FILEN: XNPANLV2.SCH

TITLE	XNET SUB-PANEL BOARD
-------	----------------------

CLIENT: MICROCAST

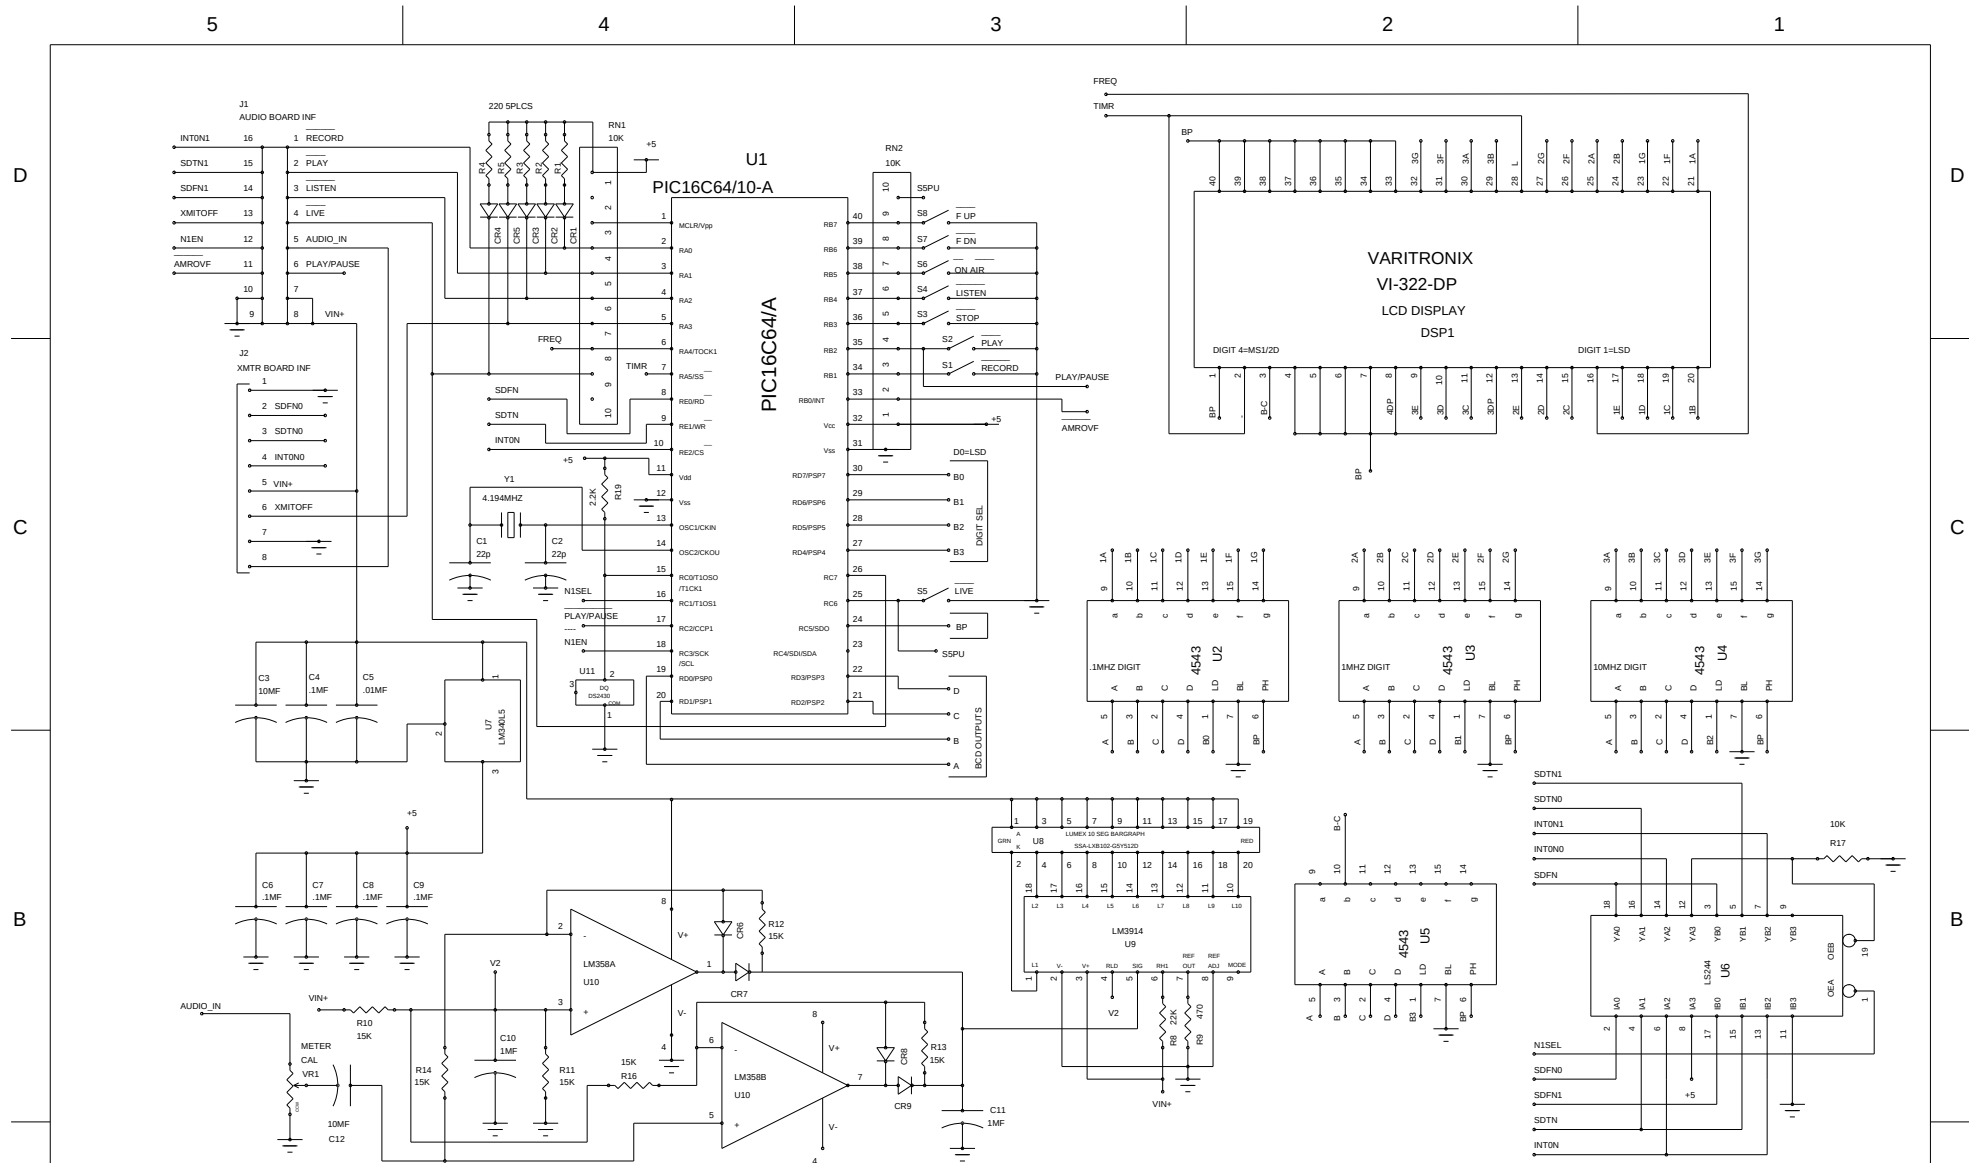
THE OLD U6 (4543) WAS DELETED, SOFTWARE REPLACED NEED FOR CHIP
THIS NEW VERSION ADDS TOTAL CONTROL OF 2 NOMADS,
ADDS PAUSE MODE TO THE MESSAGE REPEATER, AND CLEARS REC & PLAY
WHEN AN OVERFLOW OCCURS IN THE MESSAGE REPEATER.
